Technical Protocol 192/193: Tape Recorder MPU Card Modifications

This modification solves the "Error: Data Lost" problem caused by occasional, faulty processor reset during the power-on routine. The modifications listed below are of prime importance with the battery-buffered cards.

A812 Tape Deck MPU, PCB Layout 1.811.774.12

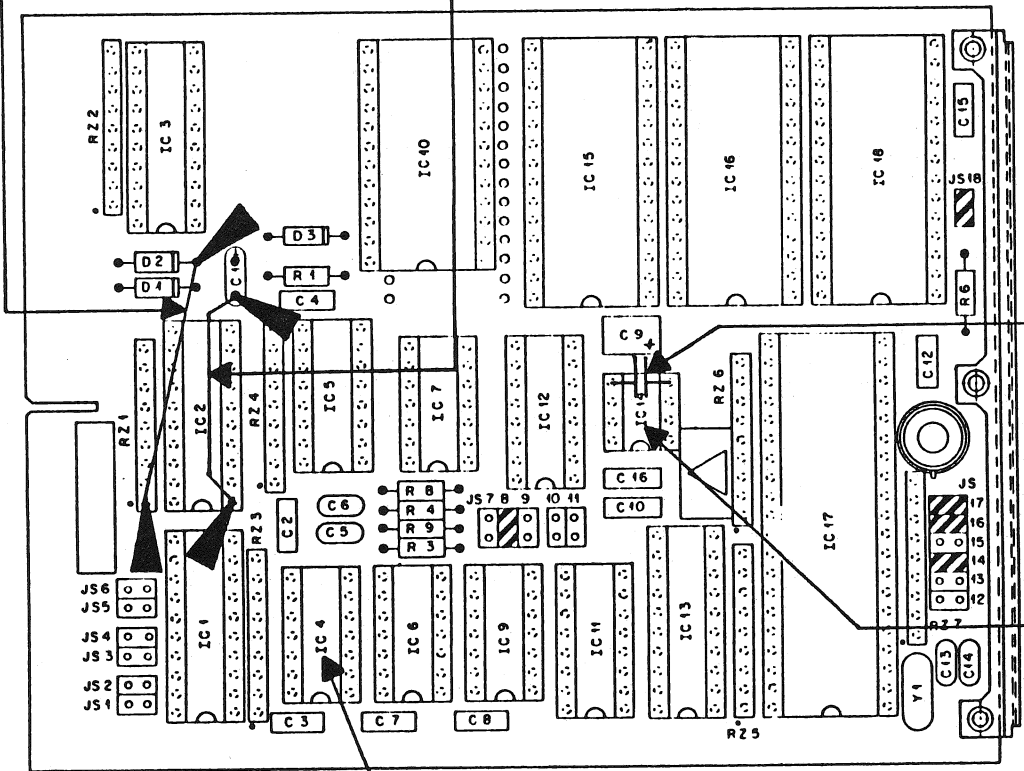
MPU Tape Deck w. PCB Layout 1.811.774.12 (A812 only) (refer to the illustrations below):

- Required materials:**
- 1 x TL7705 BCP (50.11.0157)
 - 1 x 2.2 nF / 10% / 63 V (59.06.0222)
 - 1 x wrap wire 70 mm (1.010.107.64)
 - 1 x wrap wire 90 mm (1.010.109.64)
 - 1 x wrap wire 100 mm (1.010.110.64)
 - var. index labels

- Procedure:**
- Replace IC1 (TL7705 ACP) by TL7705 BCP
 - Install 2.2 nF between IC1, pins 4 and 5
 - Connect C5, neg. (-) with JS12, shield (wrap wire 100 mm)
 - Connect IC1, pin 8 with RZ1, pin 1 (wrap wire 70 mm)
 - Connect C10, pos. (+) with IC8, pin 28 (wrap wire 90 mm)
 - Fit index label with the next number to the card's legend strip.
